PLANNING REPORT - Major Site and Building Plan Review and Variance

RE: Sunfish Lake – 415 Salem Church Road – Major Site and Building Plan
Review and Variance

Re: Site and Building Plan Review
415 Salem Church Road
City of Sunfish Lake, MN
WSB Project No. 2182-240

Re: *Site and Building Plan Review (updated plans received 04/27/17)*
415 Salem Church Road
City of Sunfish Lake, MN
WSB Project No. 2182-240

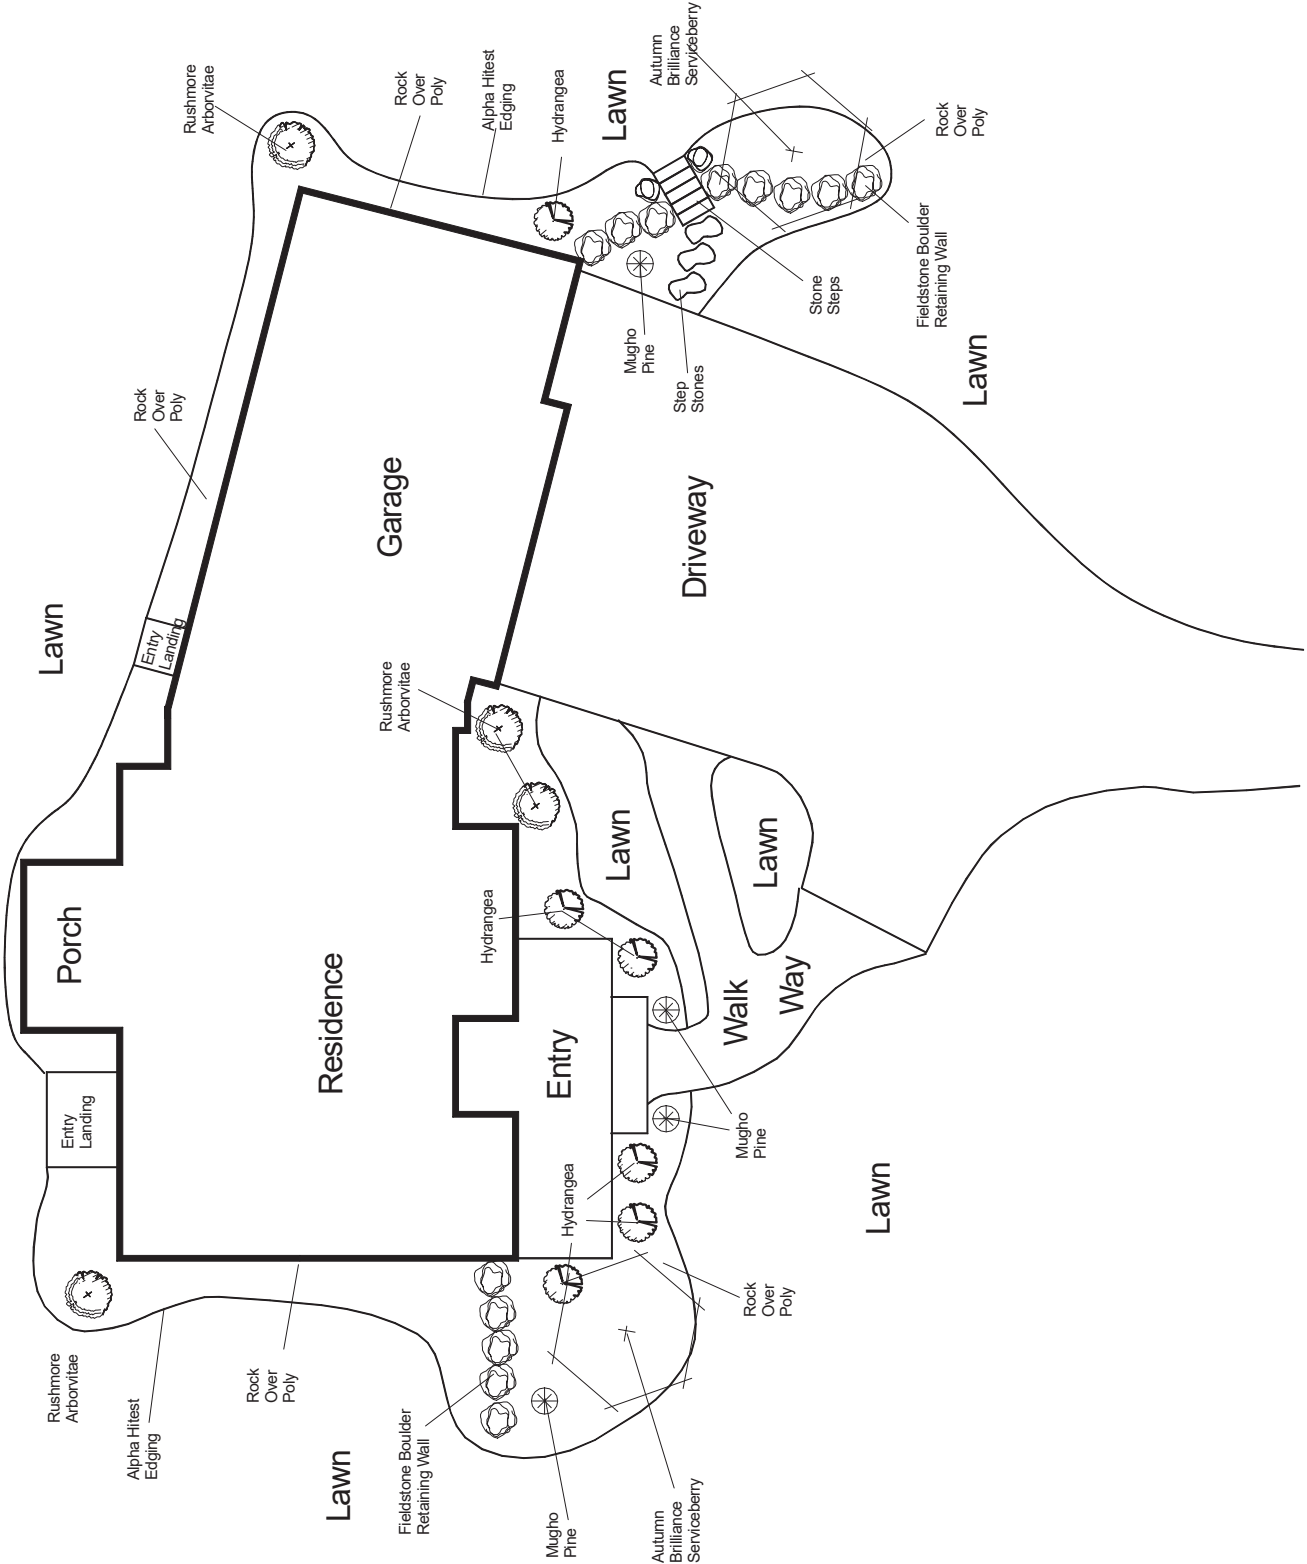
The applicant's proposed site grading shows a positive slope away from the house foundation except for the east side of the garage. It should be noted on the grading plan that a drainage swale with spot elevations is needed to ensure proper drainage in this area. The driveway width and turn around may need to be modified in order to comply with state fire codes. The driveway should be able to support a 15,000-pound axle weight, have a 20' wide access that is maintained year round (minimum of 14' paved surface), an appropriate turnaround area, and a minimum vertical clearance of 13'-6". Please work with the City Fire Chief to determine turn around requirements. Impervious calculations and disturbance areas shall be adjusted on the plan set accordingly.

- The proposed grading appears to direct runoff towards an adjacent property. City ordinance requires that the applicant obtain any necessary easements or other property interests concerning flowage of water. As such, any required drainage easements should be added to the planset.

- Any slopes steeper than or equal to 5 to 1 horizontal to vertical will require erosion control blankets.
- The retaining walls shown on the plans have been revised and all under 4 feet in height. Therefore, no retaining wall plans need to be submitted for review.
- The proposed impervious area for the driveway in the upper right corner of survey sheet 1 differs from the label on the driveway. Please verify the correct amount of impervious area.

- Volume Reduction: Volume reduction goals have been adequately addressed by the proposed stormwater management. The infiltration basin is oversized for the proposed impervious area. The plans and report indicate that there is about 7400 square feet of impervious surface, including 3756 square feet of driveway area. As mentioned, the plans also show a label in the driveway area indicating 4261 square feet. Assuming the larger of

these areas is the correct area there is still sufficient capacity in the infiltration basin. For project completeness, the report and figures should be updated with the correct values.

- Infiltration Basin EOF: The infiltration basin grading should be modified such that there is a minimum of 0.5 feet of freeboard from the 100 year HWL elevation. Modifying the 940 contour around the basin appears to be feasible and this would be 0.5 feet above the 100 year HWL elevation of 939.5 feet. Currently the pond will overflow uncontrolled at elevations higher than 939.5 feet, which could create erosion and drainage issues on site and off site. Also, the EOF should be armored with turf reinforced mat or rip rap to prevent excessive erosion when the EOF is utilized.

The applicant's proposed site grading shows a positive slope away from the house foundation except for the east side of the garage. Notes on the grading plan with spot elevations has been provided ensure proper drainage in this area. The driveway width has been approved by the fire chief.

REAR ELEVATION
 1/4" = 1'-0"

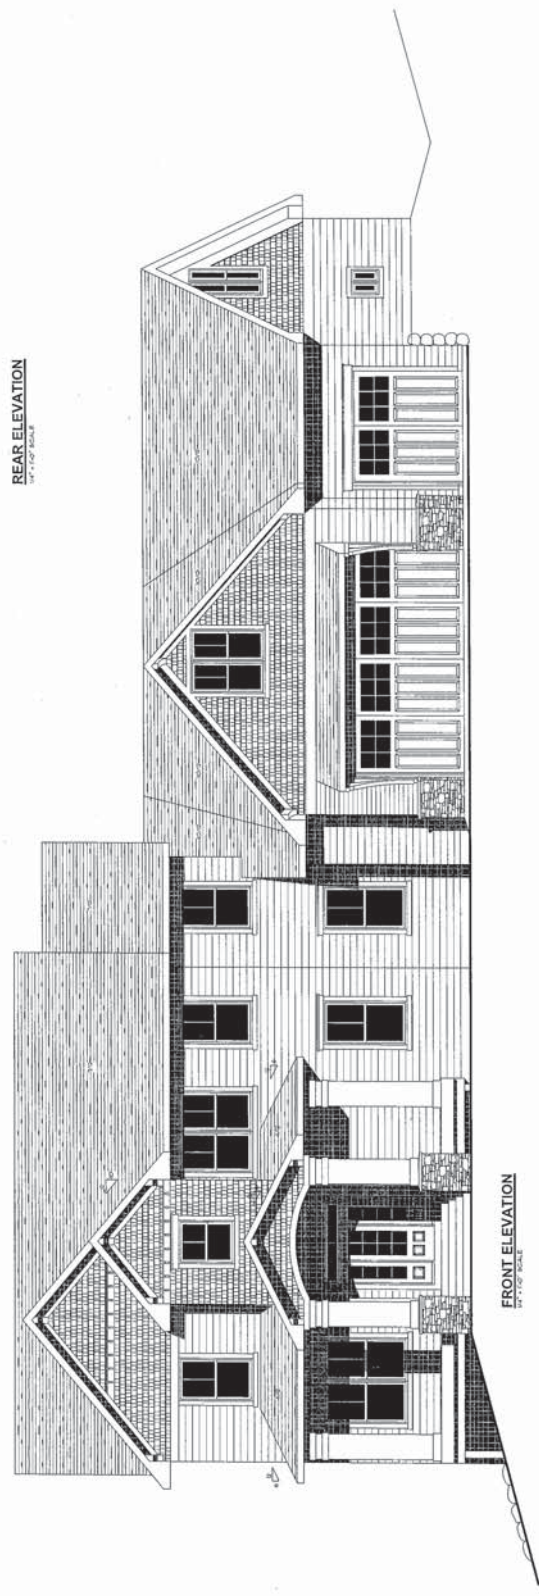
Building Height / Elevation. According to the Ordinance, no building structure shall exceed two and a half stories or 30 feet in height above average existing grade. The roof of the proposed two story structure is non-conforming at 34 feet above average existing grade. (It should be noted that this information can be found on the site plan rather than the building plan.) The applicants are requesting a variance from the building height (discussed later in this report).

The Building's elevation will be 987.6 feet at the peak of the roof. It should be noted, that the peak elevation of the home to the east is 991.9 feet.

The updated site and building plan includes moving the home 10 feet to the west which brings the home down 36 inches. In addition, the revised plans reduce the heel height of the trusses, and the pitch of the roof which further reduces the height by 12 inches. This results in a home height of 30.0 feet. The home now complies with all City Codes, and no variance is required.

By moving the home 10 feet to the west, the walkout basement has been removed since the home is now on flatter ground. As a result, the base elevation of the home is altered. The original proposal had a building height of 34.0 feet, with a roof peak elevation of 987.6 feet. The revised plans show a building height of 30.0 feet and an elevation of 982.8 feet at the roof peak.

EXHIBIT F

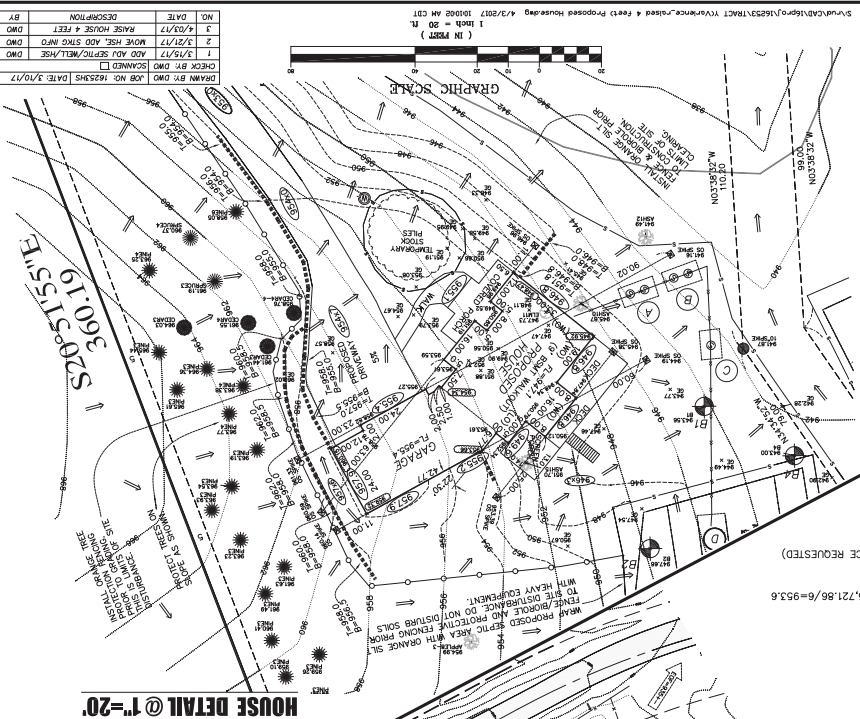
Alternative Locations. The applicant has submitted three alternative site plans. The alternatives show that a variance will still be necessary due to the fact that height is calculated as the average natural grade up to the peak of the roof. This means that the home will need a variance regardless of grading on site. It should be noted that one of the alternatives shows the home rotated roughly 90 degrees clockwise. While this layout would not require a variance, it results in an acute driveway angle, not suitable

- g. Positioning the home on the site without a variance will result in an acute angling of the driveway, not suitable for fire access (Exhibit F).
2. If the Planning Commission finds that the variance request is not reasonable, the following findings support denial of the variance request:

HOUSE DETAIL @ 1"=20'

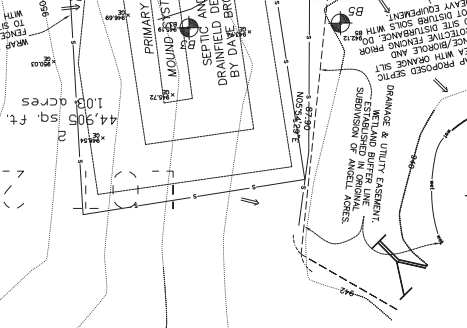
- b. Any slopes steeper than or equal to 5 to 1 horizontal to vertical will require erosion control blankets.
 - c. The proposed impervious area for the driveway in the upper right corner of survey sheet 1 differs from the label on the driveway. Please verify the correct amount of impervious area.

The applicants have also noted that all proposed retaining walls on the site plan will remain under four feet in height to be in compliance with retaining wall height requirements.
